XT303-S939

Thermostat Housing Hose –  
Install Additional Hose Clamp –  
Service Action S939

MODEL 2002-03 MY  
X-TYPE

ILLUSTRATION 1

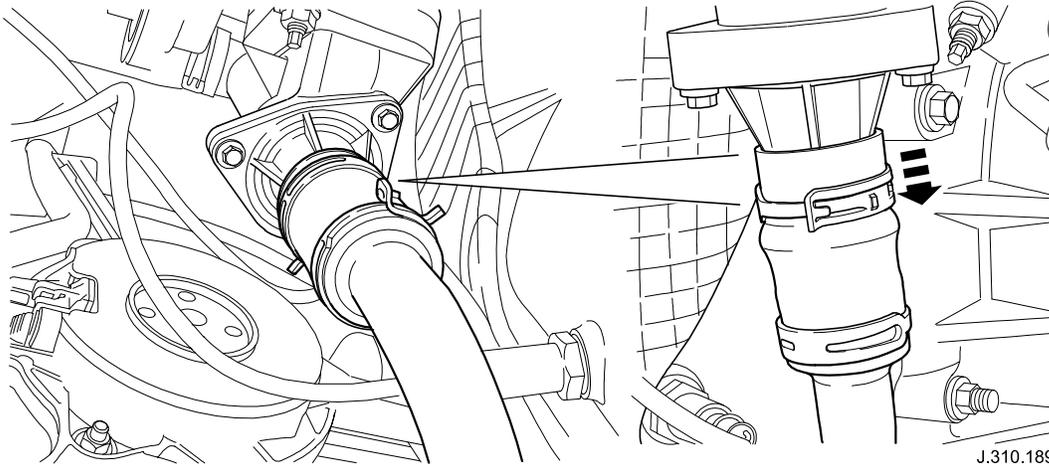
On a number of X-TYPE vehicles within the above VIN range, the spring band clamp used on the hose joint between the engine oil cooler outlet hose and the thermostat housing inlet spigot is susceptible to ‘walking’. In extreme cases this can lead to the failure of the joint causing loss of engine coolant.

3. Reposition the hose fully upwards to abut the thermostat housing webs.
4. Reposition the spring band clamp close to the bulge in the hose formed by the bead of the thermostat spigot. Illustration 1.

**Note:** Spring band clamp to be close to, but not on the hose bulge.

ILLUSTRATION 2

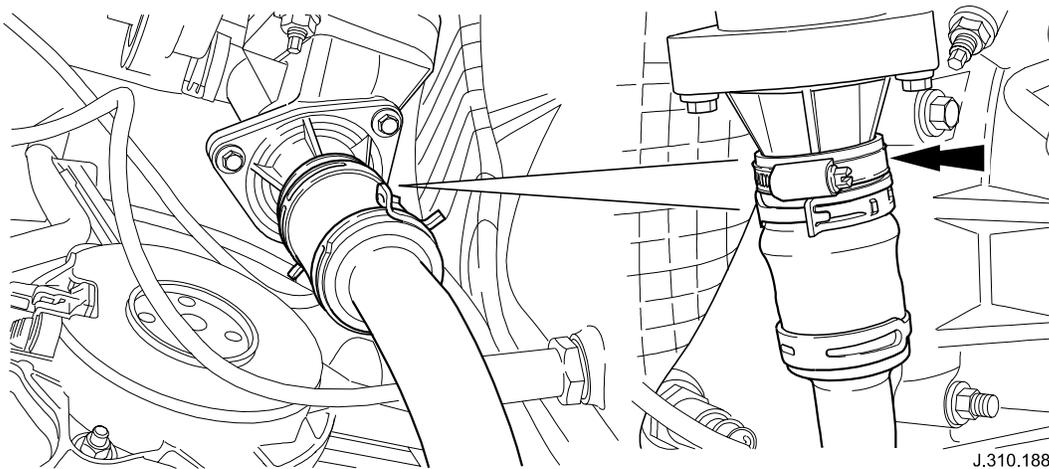
5. Fit an extra 9 mm wide, 32-50 mm Norma worm drive clamp above the existing spring band clamp and tighten to 4.1 Nm +/- 0.7 Nm tolerance. See Illustration 2.

**Note:** Fit worm drive clamp against the spring band clamp so that the hose protrudes above the worm drive clamp.
